Comhairle Contae Chiarraí Kerry County Council

Insulated Concrete Formwork-ICF Fire Officers Perspective

PRESENTER: NOEL CRONIN & MICHAEL FLYNN

▶ 31 | JANUARY | 2024

Construction Detail (ACD)

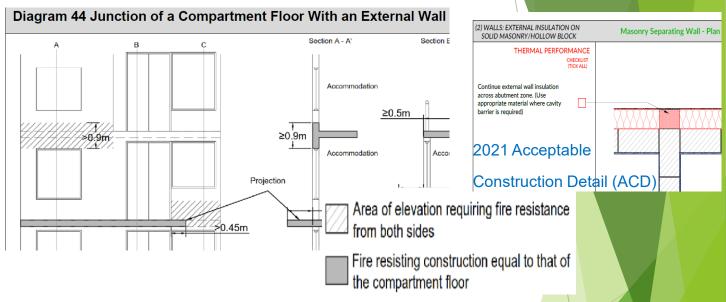
How do you deal with a "stepped" elevation – Architectural detail with ICF.

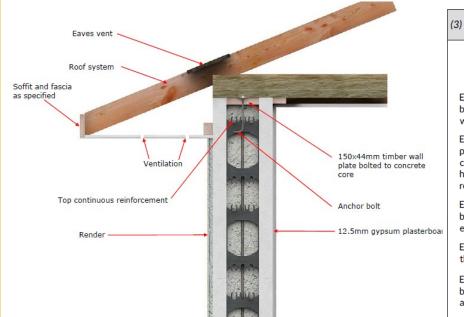
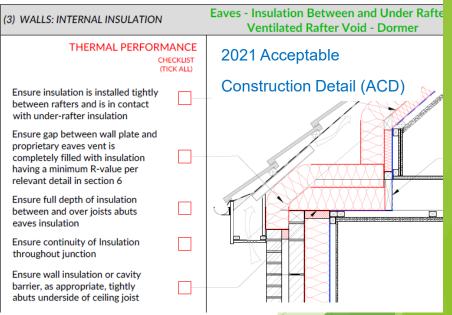
New DRAFT TGD-B 2023 – shows 900mm fire resisting construction to external wall at compartment floor.

Compare ICF details to Acceptable Construction Details ACD's – Some differences.

7) Agrement Certificate Scope to be considered Argue it is not a cavity or a fire barrier is not required is questionable. EPS = 98% Air

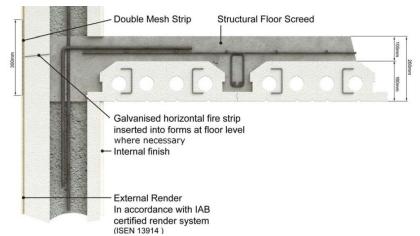
Figure x; The xxx proprietary EPS "Cavity Closer" is made of EPS, a Euro Class E product.

TGD B requires a Cavity Barrier to have a fire resistance of EI 15 & E30.

If a uPVC window frame fails in a fire the fire/heat/smoke can easily spread to the EPS.

Figure 10: Movement/Expansion Joint Detail

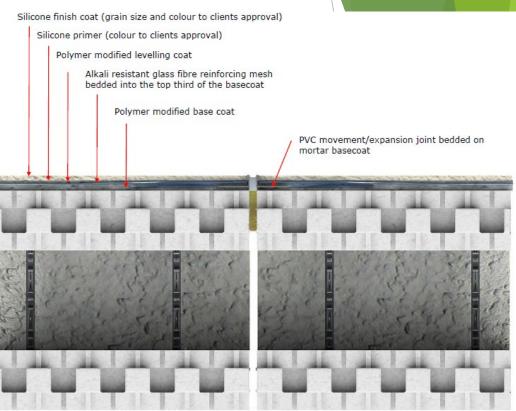
It would be beneficial if guidance was given when this movement joint is required.

These locations need to be decided by the Structural Engineer.
